## State Agencies or Elected Representatives

### Letter B: Warren Frace, City of Paso Robles (February 19, 2021)

**Subject:**  
**City of Paso Robles' Agency Comment on the Draft Environmental Impact Report for the Estrella Substation and Paso Robles Area Reinforcement Project**

1. 46 East / Union Interchange PAED Alternative 2

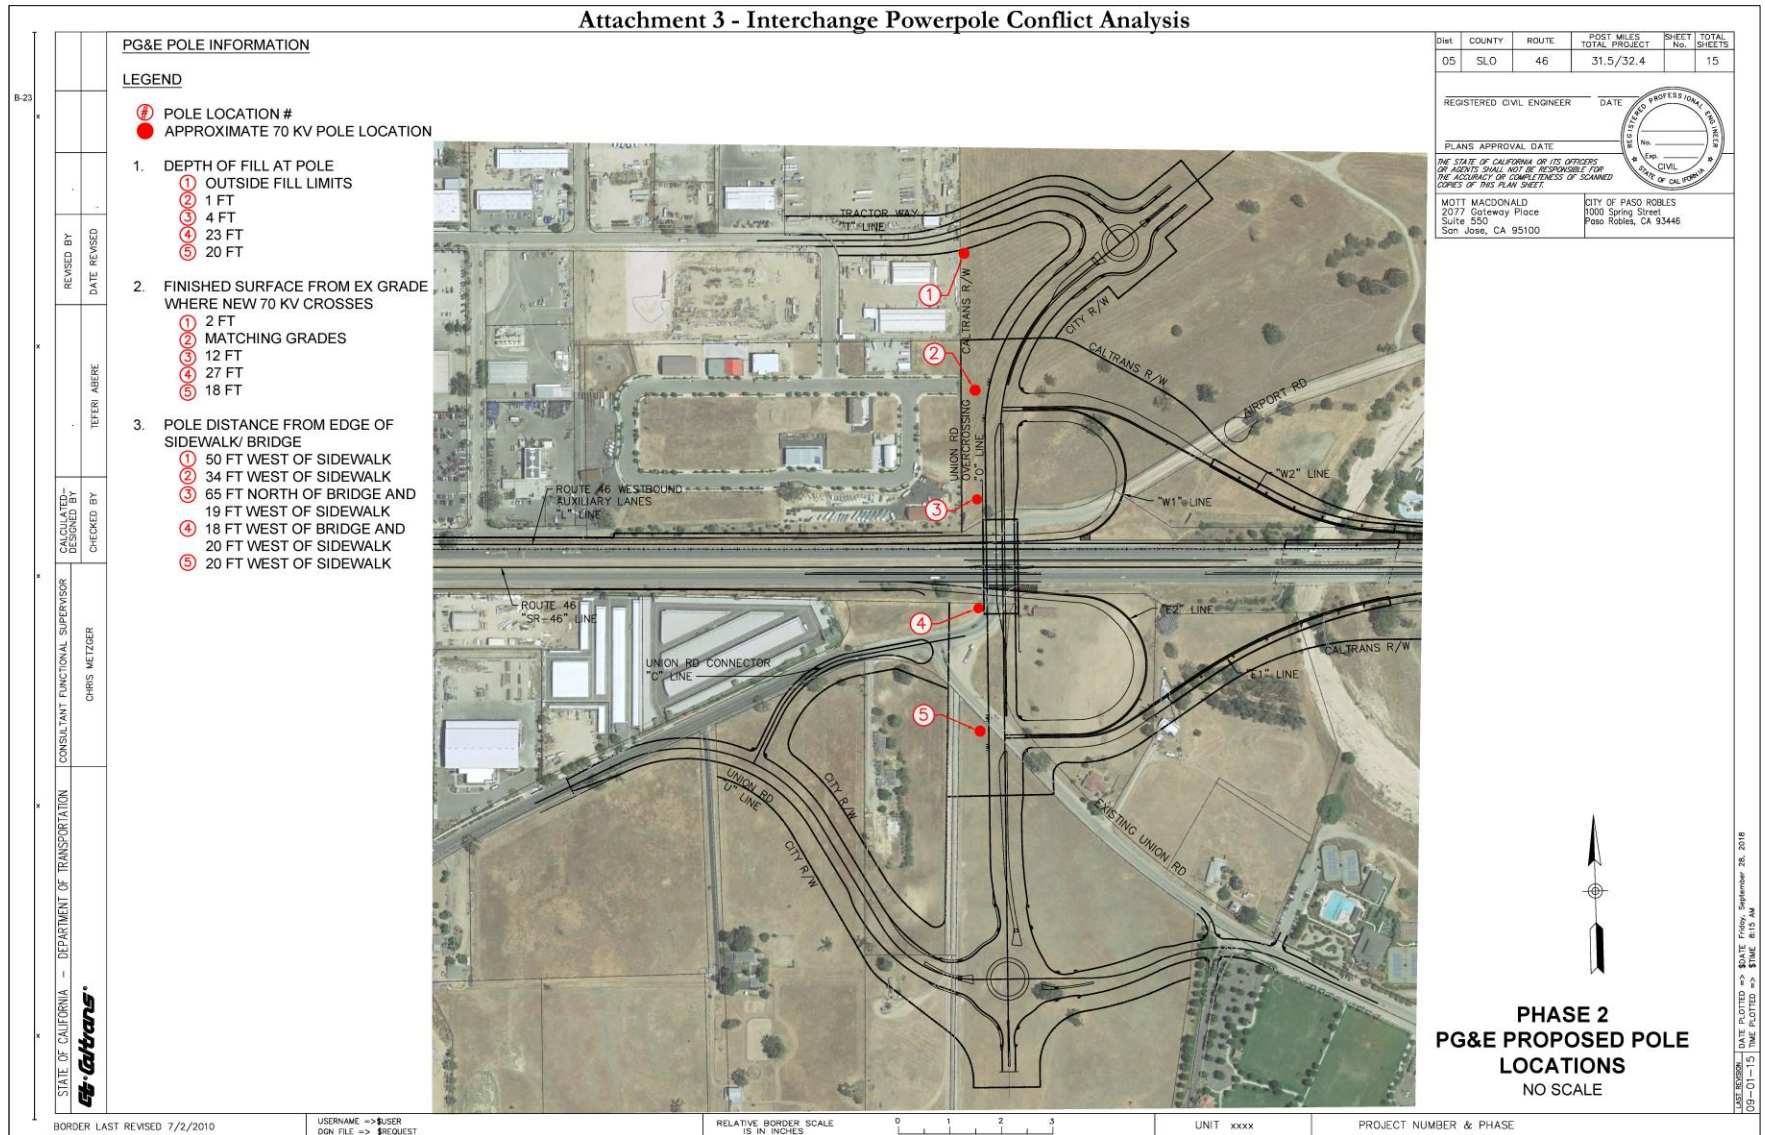
B-9 5. **Inadequate Analysis of the Union Road / 46 East Overcrossing Bridge**  
 The City, Caltrans and the San Luis Obispo Council of Governments (SLOCOG) have been working for over a decade on the design of the State Route 46 overcrossing bridge at Union Road. Caltrans has identified this project as a top priority in San Luis Obispo County due to the important freight traffic connection between US 101 and Interstate 5. This project is currently in the Project Approval and Environmental Determination Phase (PAED) and will be moving into project design and funding in 2022. Funding of the project is a major challenge, and the design of the DEIR project places four new poles in conflict with the interchange project (refer to Attachment 2 – Analysis of PG&E Pole Locations). Due to significant funding constraints, the Bridge Project cannot include the cost to relocate the poles and increase the heights of the poles to provide clearance of the new Union Road

alignment. The project DEIR did not include analysis of transportation impacts if the bridge is not constructed due to conflicts and cost overruns caused by the DEIR's project construction.

comment states that, due to significant funding constraints, the Bridge Project cannot include the cost to relocate the poles and increase the heights of the poles to provide clearance of the new Union Road alignment, and states that the DEIR did not include analysis of transportation impacts if the bridge is not constructed due to conflicts and cost overruns caused by the Proposed Project's construction. In response to Comment B-9, the text in Section 4.17, "Transportation," (see Volume 1 of the FEIR) has been updated to include information provided by the City of Paso Robles regarding the Bridge Project. Specifically, page 4.17-4 has been revised as follows:

The changes to the EIR described above would not result in changes to environmental impact analyses or conclusions presented in the DEIR, and therefore do not constitute significant new information that would trigger recirculation under CEQA Guidelines section 15088.5. Rather, the changes serve to clarify and amplify the content of the DEIR.

This comment depicts site plans of the proposed half-clover leaf interchange layout and powerpole conflict analysis shows potential conflicts between the Proposed Project's 70 kV poles and the Bridge Project. Please refer to Response to Comment B-9.
